# THE COMMISSION OF FINE ARTS

## MEETING OF THE COMMISSION OF FINE ARTS

18 January 1990

18 January 1990

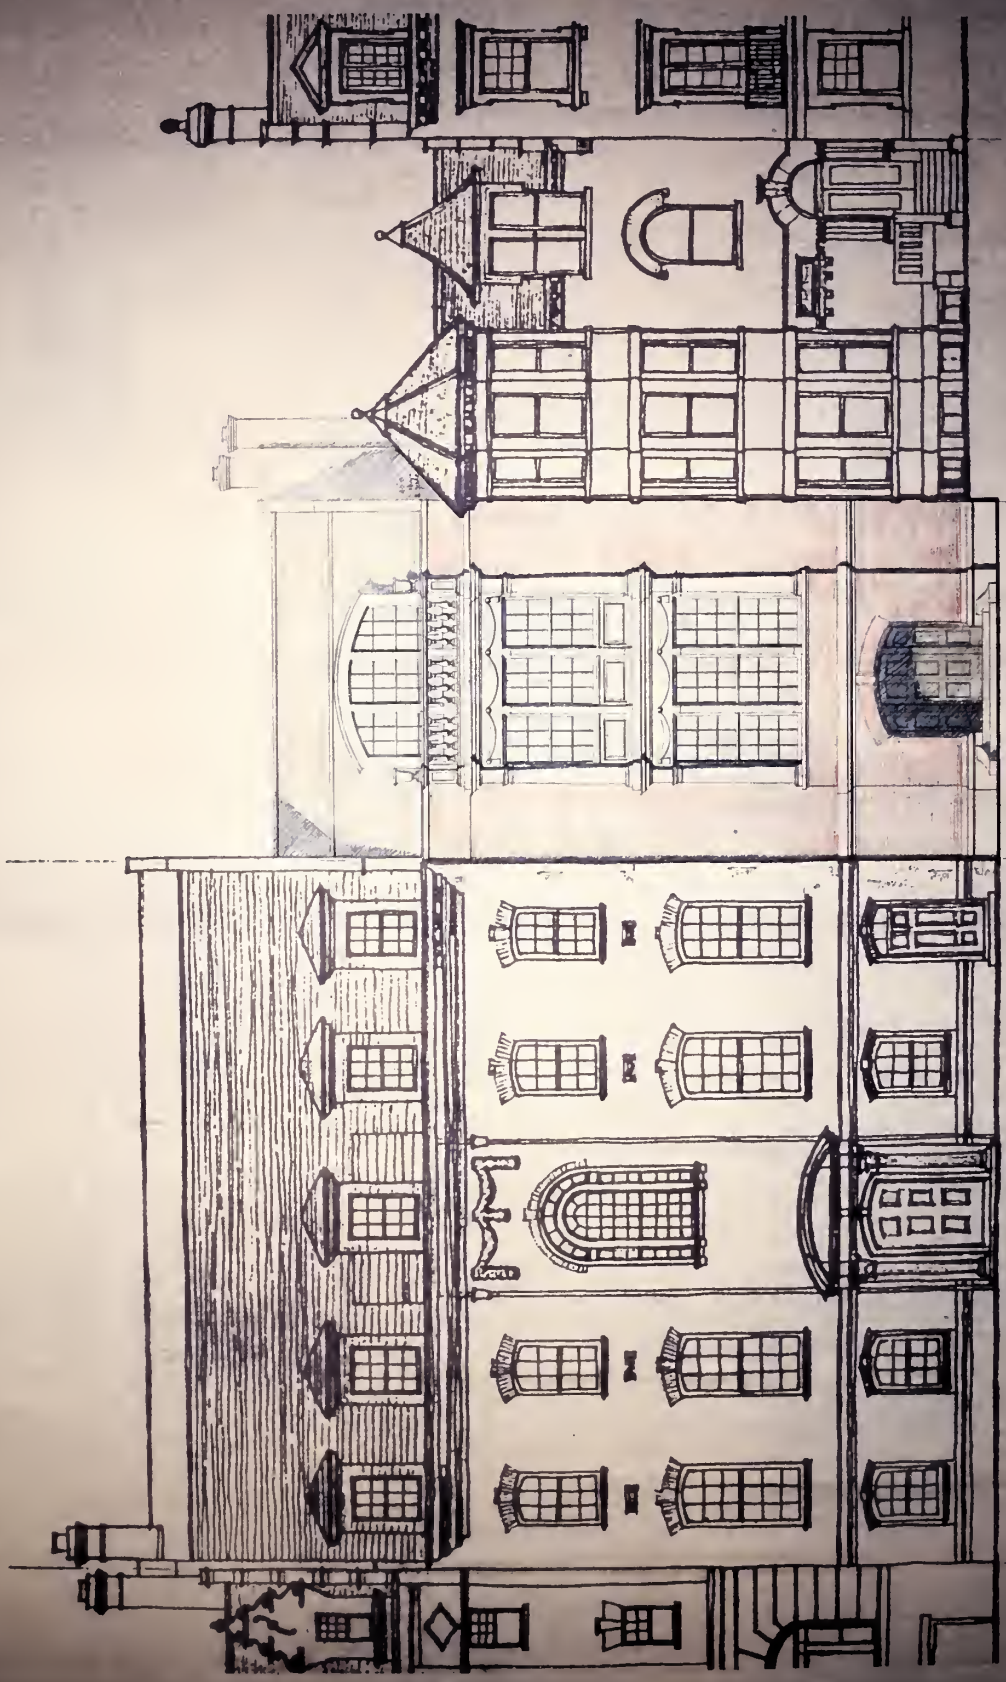
b. S.L. 90-52, 2356 Massachusetts Avenue, N.W. Infill addition. Concept design. (The Chairman recused himself during the review of this project.) Mr. Carson described the site, noting that it was in the Massachusetts Avenue Historic District, and said the D. C. Historic Preservation Review Board had approved the addition. The ANC had also approved it, except for the treatment of the front courtyard along Massachusetts Avenue; there were objections to the amount of paving, the loss of green space, and the possibility of parking four to six cars in the space. Mr. Carson said that since the ANC review, the architect had revised the design. He showed a photograph of the existing house, a neighboring house to the west, which the applicant had purchased, and the side garden between, which would be the site for the addition. He said the addition was designed to appear as a separate townhouse. Architect Leon Chatelain was then introduced to describe the project in more detail.

Mr. Chatelain said the main house was a 50-foot-wide Georgian Revival structure designed in 1905-06 by Washington architects Wood, Donn & Deming. The adjacent property, including a side yard and late Victorian house, was also 50 feet wide, making a 100-foot frontage along the avenue. In order to break up the long frontage and preserve the traditional streetscape of the area, the addition had been given the appearance of a separate townhouse; in style, it would be compatible with both existing houses, relating to the architecture of the period between 1895 and 1925.

Mr. Chatelain said the granite cobblestone courtyard in front of the Georgian house would be extended to the addition, with an expanded green space between that and the parking in front of the Victorian residence; one curb-cut would be removed. In the rear there was an unusual lot configuration, bringing a wedge of Rock Creek Park into what would normally be part of the private lot. To simplify and straighten out the back garden area, he was proposing to remove two rear additions to the Victorian house, adjust the fenestration and add a three-story bay window.

architecturally was united on the site plan by the landscaping treatment and the extension of the paving and fencing along the entire frontage. Mr. Porterfield agreed, thinking that the ensemble should not be made more pretentious; he suggested changing hedge heights and not expanding the existing length of wall and fence. He and Mr. Hartman gave Mr. Chatelain more specific suggestions on how he might proceed with the landscaping and fencing, entrances into the property, and the parking of cars. Mr. Chatelain observed that since both houses would now be used by just one owner, the number of cars parked in the courtyard would seldom exceed two.

ACTION: No objection to general concept design for proposed in-fill structure attached to the existing residence at 2346 Massachusetts Avenue. Recommend replacing proposed brick and wrought iron ornamental fence at front of new structure with hedge and landscaping as a means of reinforcing the appearance of a separate residence. No objection to alteration of existing structure at 2356 Massachusetts Avenue. Submit working drawings and detailed landscape plans for permit review when ready.
